# TECHNICAL BULLETIN

## Hood Panel – Difficult To Latch – Revised Latch and Hood Release Lever Guard Introduced – Service Action S448

**76-96**

MODEL XJS Range 1994 - 1995 MY      DATE 11/94

ILLUSTRATION 1

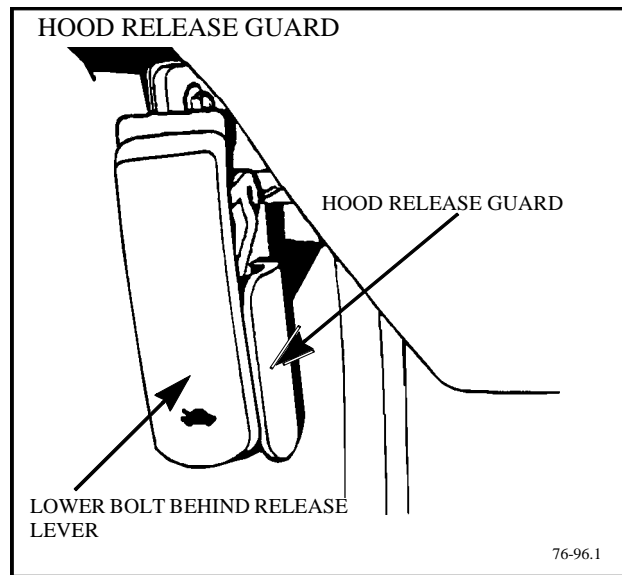
To prevent inadvertent operation of the hood release, a release lever guard was introduced in production at VIN 194776.

**FITTING HOOD RELEASE LEVER GUARD:**

1. Remove the lower bolt of the hood release lever.
2. Align the guard as shown in Illustration 1 and replace the lower bolt.

ILLUSTRATION 2

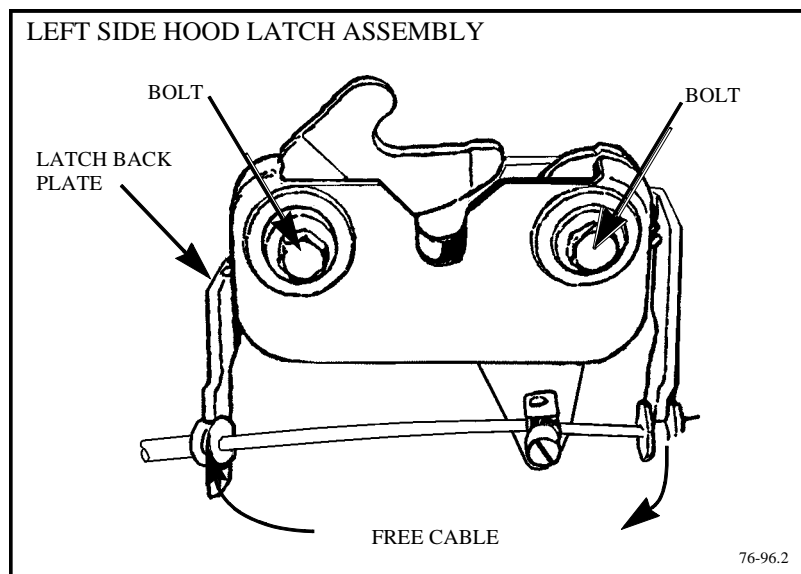
Latches are now lubricated and revised latch back plates (cable end retaining brackets) are installed in production beginning with VIN 196255.

The revised latch back plate accomplishes the following:

- Prevents the latch pawl from going over center
- Increases the pawl return spring pressure to aid hood “pop-up” when the hood is released.

1. Mark the position of both hood latches on the engine compartment bulkhead.
2. Remove the two bolts holding the left side latch assembly to the bulkhead (Illustration 2).
3. Free the release cable from the latch back plate, then remove and discard the back plate.

ILLUSTRATION 4

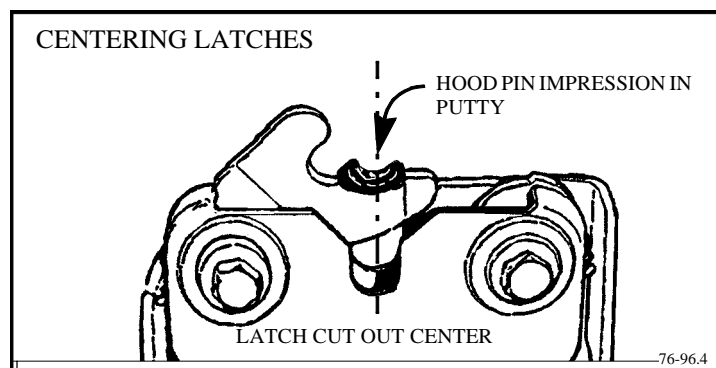
This condition is caused by friction in the latch pawl pivots.

6. Insert the hood release cables into the slots in the latch back plate.
7. Align the latch assembly to the marks on the bulkhead and tighten the mounting bolts.
8. Repeat steps number 2 through 7 for the right side latch assembly.
9. Grease the latch pawl springs and the pivot points on both latches with multipurpose grease.
10. Loosen the release cable clamp bolts on both latches. Pull the cable end of the right latch to remove any cable slack, release the cable. Tighten the right side cable clamp bolt first, then tighten the left hand cable clamp bolt.
11. Place body putty or “dumdum” on both latches as shown in Illustration 4.
12. Move the hood down until both hood pins make impressions in the putty. The hood pin impressions must be in the center of the latch cutouts (Illustration 4). If necessary, move the latch assembly left or right to center the latch cutout to the hood pin.
